Vincotech – PCN – No 17-2020

SUBJECT OF CHANGE:	Modification of the MiniSKiiPO DCB backside layout
PRODUCTS AFFECTED:	K61x (see PRODUCT IDENTIFICATION section for detailed part #)
REASON OF CHANGE:	Reliability improvement

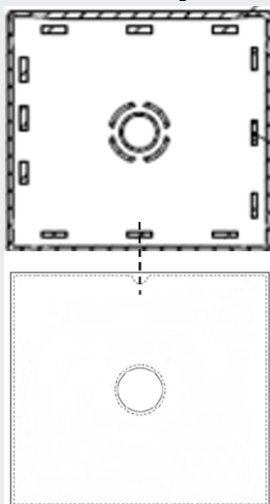
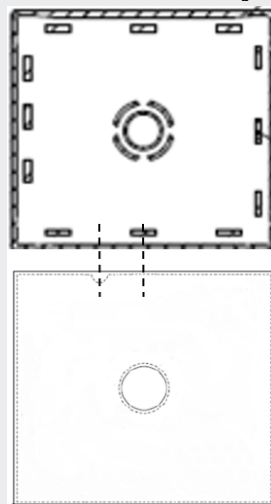
CURRENT	NEW
Replacement of positioning marker on the backside of the DCB	<p>Presspin on housing in the same line with positioning marker on DCB backside Cu layer</p> 	<p>Presspin on housing not in the same line with positioning marker on DCB backside Cu layer</p>
